**RE: R.C.O.C. PRELIMINARY PLAN REVIEW 25P0013**  
**LOCATION: 1150 E AVON RD, ROCHESTER HILLS**  
**PROJECT NAME: INDUSTRIAL BUILDING**

**Industrial Building - 1150 E. Avon**  
Concept Plan Review

PCP2025-0004

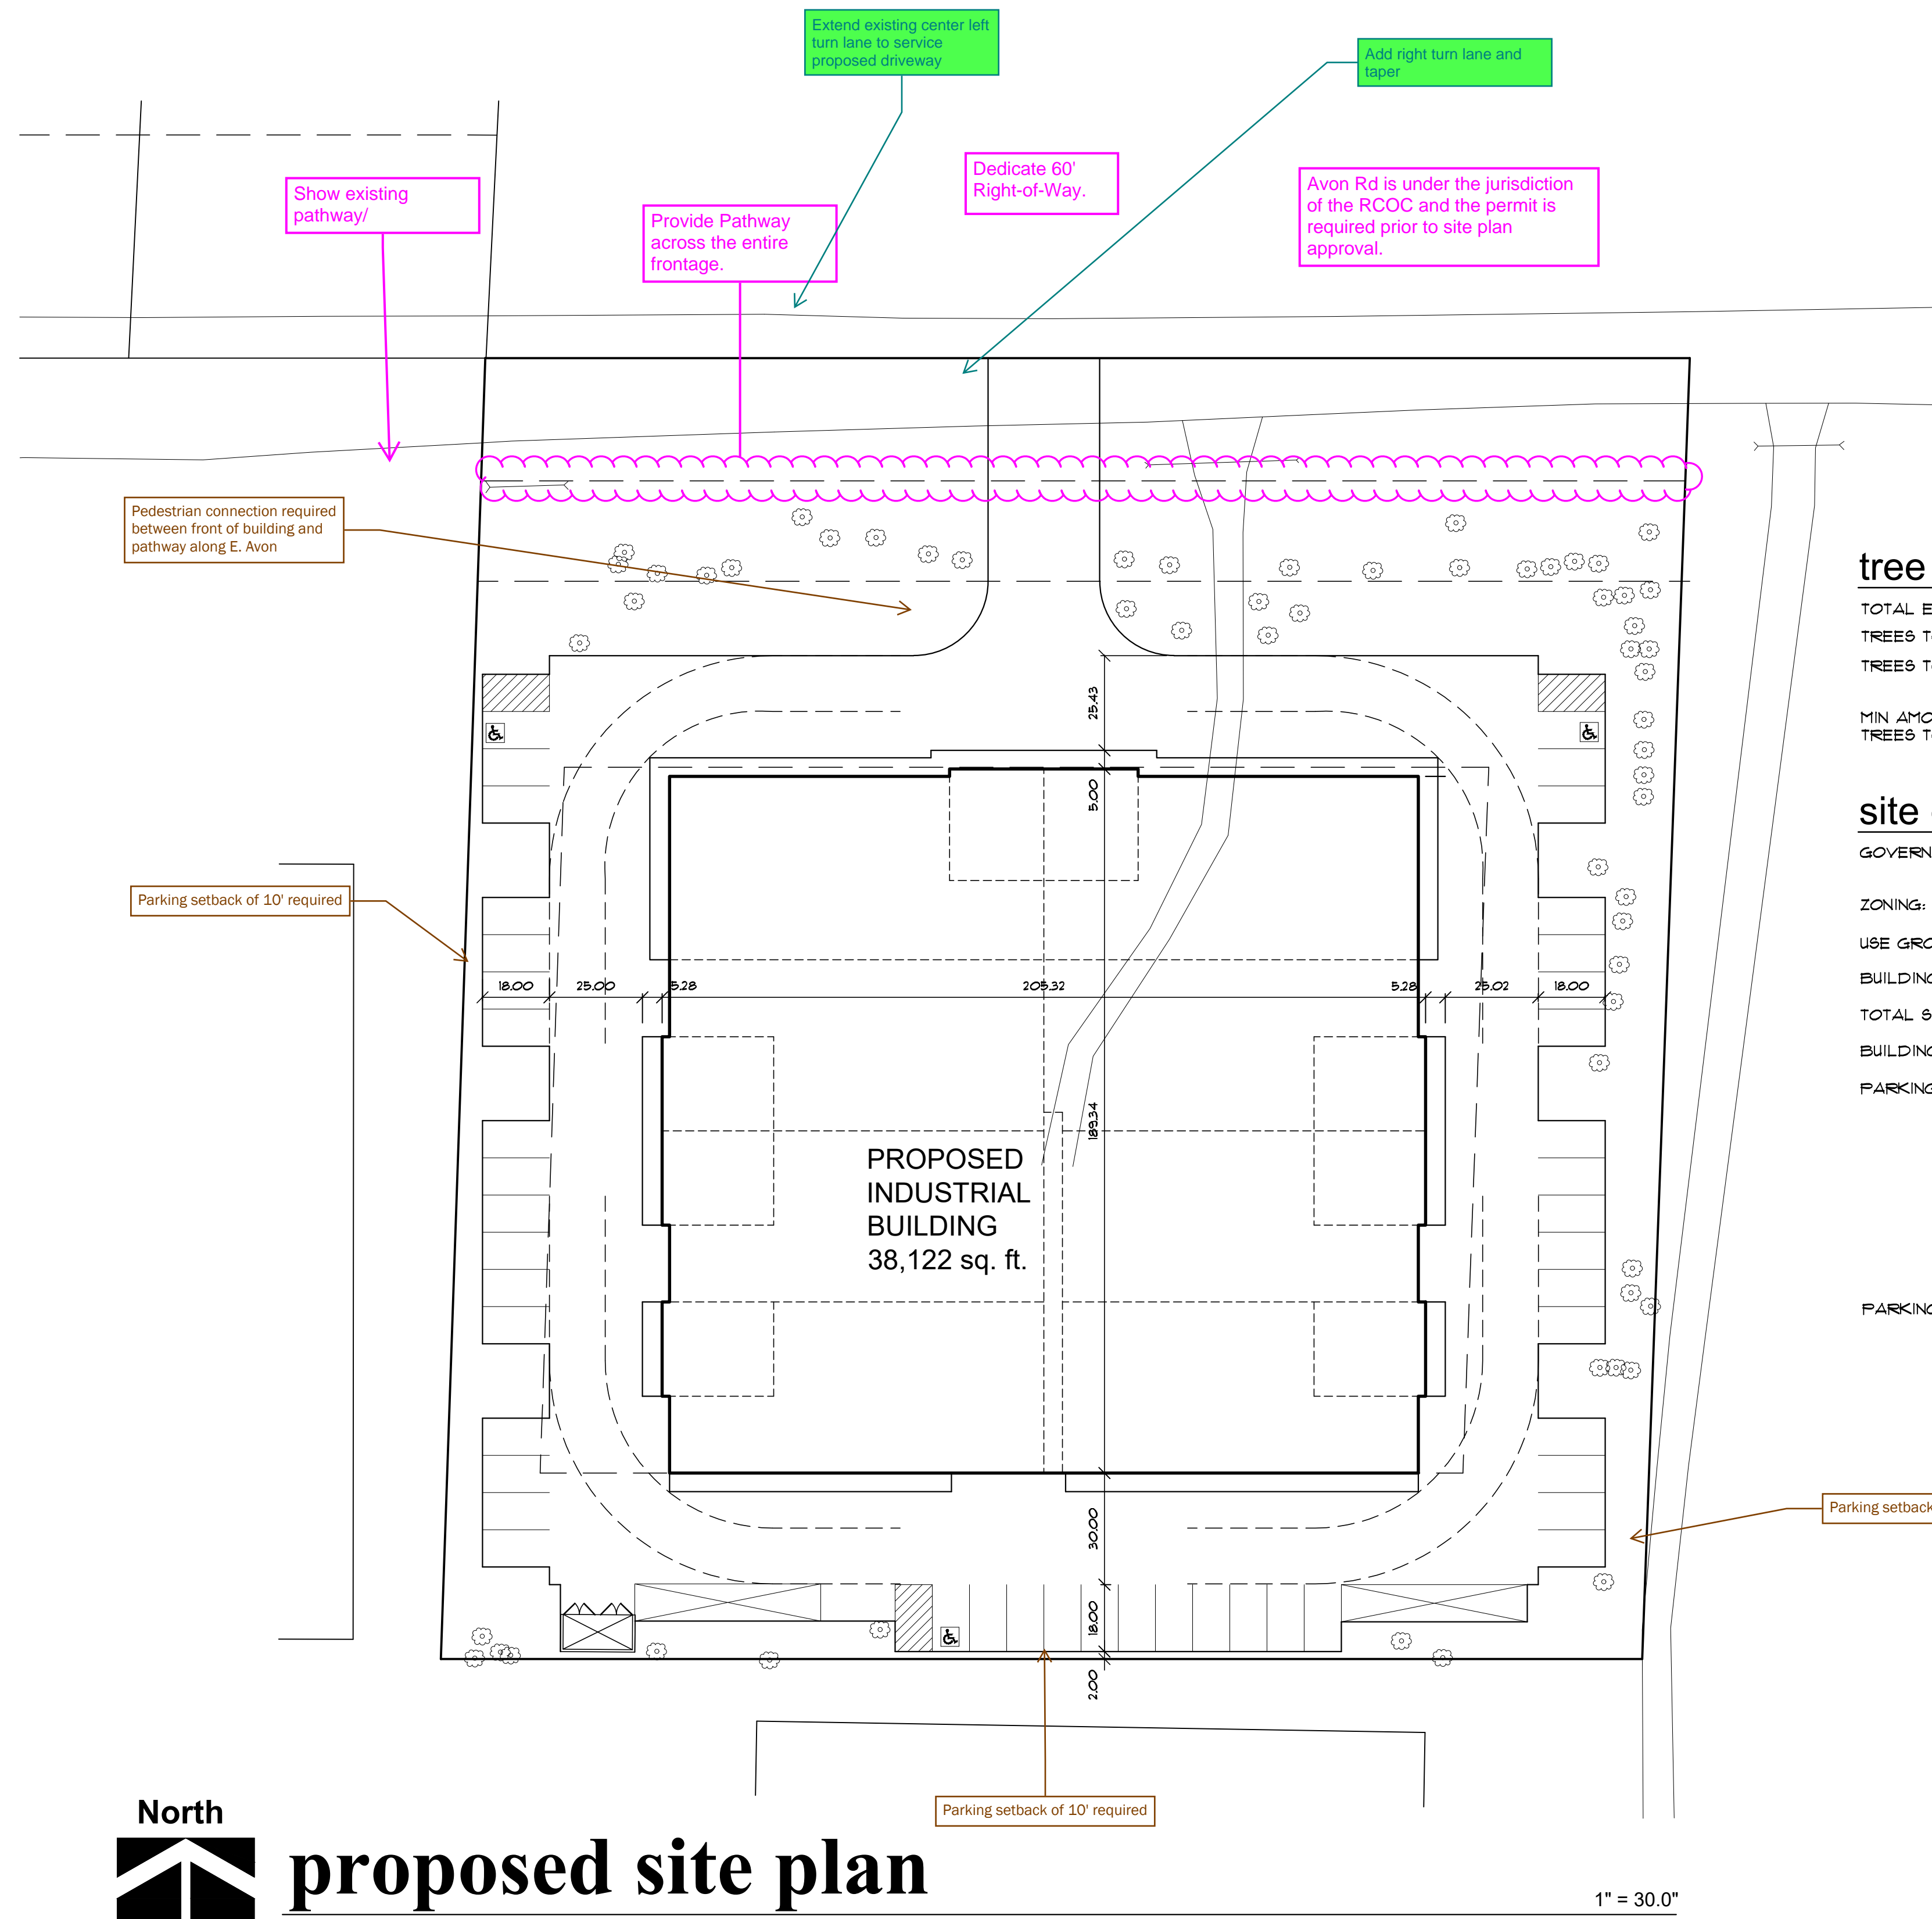
- A) The RCOC Master ROW Plan indicates a 60-foot wide half width ROW for Avon Road. The existing ROW is shown to be 33-foot wide half width. Please contact Right-of-Way Department, at (248) 645- 2000 to discuss dedicating the ROW or establishing a dedicated highway easement.

- B) Extend existing Center Left Turn Lane to the West to service the proposed drive approach to allow Eastbound traffic lefts to the site.
- C) Proposed drive approach must include a Right Turn Lane (RTL) and accel/decel taper. Also, include a detail M curb line to provide controlled drainage across the driveway.

- D) Driveway must have sufficient corner sight distance.
- E) Remove or relocate all fixed objects prior to excavation. Fixed objects shall be no nearer than 6 feet from back of curb, or 12 feet from lane line.

- F) Site drainage shall not drain directly into road right of way.
- G) Right of way shall be graded to provide positive roadside drainage across the property frontage.

- H) Pavement cross section shall consist of a minimum 2 inches of MDOT 5E HMA, over 3 inches of 4E, over 4 inches of 3E, or 9 inches of MDOT 35-P concrete, with epoxy coated rebar lane and curb ties over a suitable base, as determined in the field by RCOC.
